World Forum for Harmonization of Vehicle Regulations

Working Party on Passive Safety

Proposal for the 04 Series of Amendments to UN Regulation No. 137 (Frontal collision with focus on restraint systems)

Submitted by the expert from Japan^{*,}**

Model A

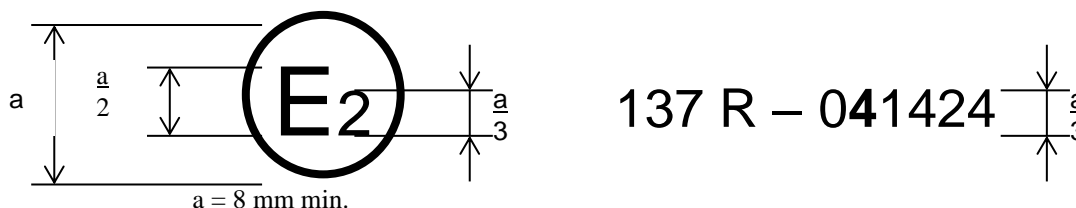
Annex 2, amend to read:

The above approval mark affixed to a vehicle shows that the vehicle type concerned has, with regard to the protection of the occupants in the event of a frontal collision, been approved in France (E 2) pursuant to Regulation No. 137 under approval number 0341424. The approval number indicates that the approval was granted in accordance with the requirements of Regulation No. 137 034 series of amendments.

Model B

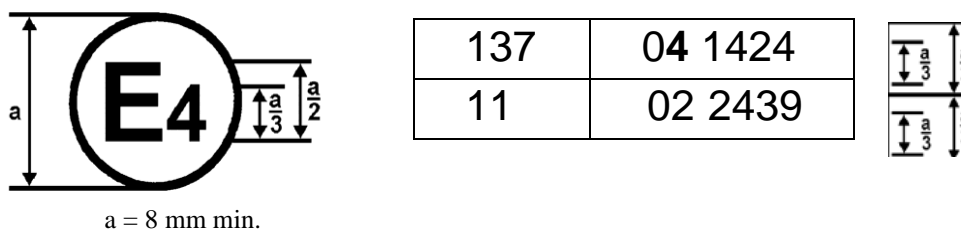
The above approval mark affixed to a vehicle shows that the vehicle type concerned has been approved in the Netherlands (E 4) pursuant to Regulations Nos. 137 and 11.¹ The first two digits of the approval numbers indicate that, at the dates when the respective approvals were granted, Regulation No. 137 incorporated the 034 series of amendments and Regulation No. 11 incorporated the 02 series of amendments."
